Item ID: D212-664-101

Item Name: Crosstube Fwd

<b>DART AEROSPACE LTD</b>		<b>Work Order:</b>	7560
<b>Description:</b> Crosstube High Fwd (205/212/412)		<b>Part Number:</b>	D212-664-101
<b>Inspection Dwg:</b> D212-664-141 <b>Rev:</b> D		<b>Page 1 of 1</b>

DRAWING NO. D212-664-141	TITLE XTUBE ASSY (205/212/412 HI FWD)	REV. D	DART AEROSPACE LTD ENGINEERING ORDER		D.E.O. NO. D212-664-141-D-1	SHEET NO. SHEET 1 OF 2	SCALE NTS
DRAWN	CHECKED	MP	MFG. APPR.	ER	APPROVED	MP	DE APPR.
DATE 11.04.07	DATE 11.07.11		DATE 11.04.12		DATE 11/04/12		DATE 11.04.12

**D212-664-141/-141B  
ASSEMBLY DETAIL**

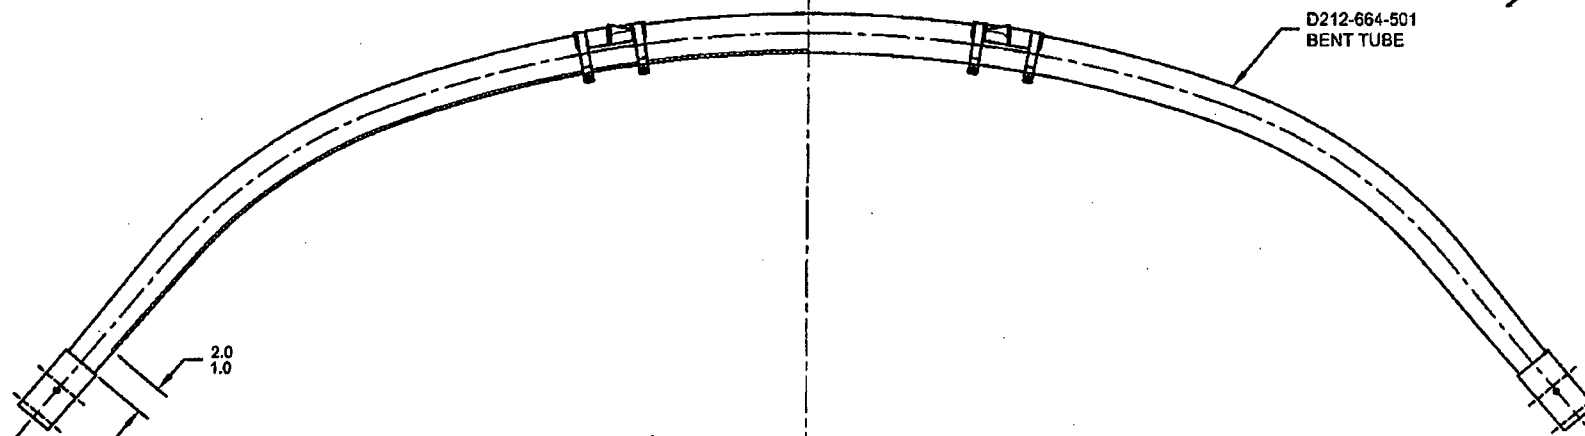
ADD AN INSPECTION WINDOW TO UNDERSIDE OF CROSSTUBE.

NOTES 2 OF SHEET 1 IS AMENDED AS FOLLOWS:

- 2) FINISH: CHEMICAL CONVERSION COAT PER DART QSI 005 4.1  
PRIME INSIDE AND OUTSIDE PER DART QSI 005 4.2  
MASK UNDERSIDE OF CROSSTUBE AS SHOWN (HATCHED AREA) AND  
PAINT OUTSIDE PER DART QSI 005 4.2  
REMOVE MASKING AND APPLY CLEAR COAT

MASK AREA PRIOR TO PAINTING.  
REMOVE MASKING AFTER PAINT  
AND APPLY CLEAR COAT
